TECHNICAL SERVICE BULLETIN

MT88 Manual Transmission - Rotational Scraping Noise When Cold And In Neutral, 1st And/Or 2nd Gear With Clutch Pedal Released

24-204221 February
2024

This bulletin supersedes 23-2019. Reason for update: add 2024 model year vehicles, add an additional labor operation, and correct the part number called out in the Service Procedure.

Figure 1

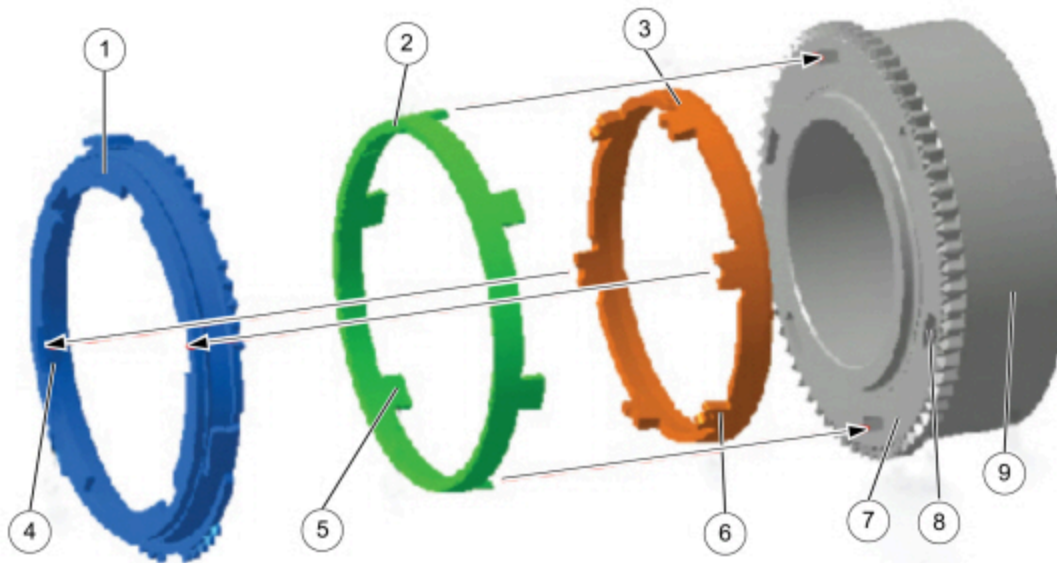
1. Remove the transmission from the vehicle. Refer to Workshop Manual (WSM), Section 308-03.
2. Disassemble the sub-assemblies to gain access to the 5th and 6th gear synchronizer rings. Refer to WSM, Section 308-03.
3. Replace the 5th and 6th gear synchronizer rings. Refer to WSM, Section 308-03.
4. Assemble the transmission. Refer to WSM, Section 308-03.
 - (1). The reverse/crawl gear synchronizer assembly must be assembled on the transmission. Refer to Figures 1-2 for an exploded view of the reverse/crawl gear synchronizer assembly (Figures 1-2).

NOTE: New 5th and 6th gear synchronizer rings are now available with an improved design to correct the rotational scraping noise. Upon receiving the synchronizer rings, check for engineering part number MU7R-7107-GA or later which will be stamped on the rings.
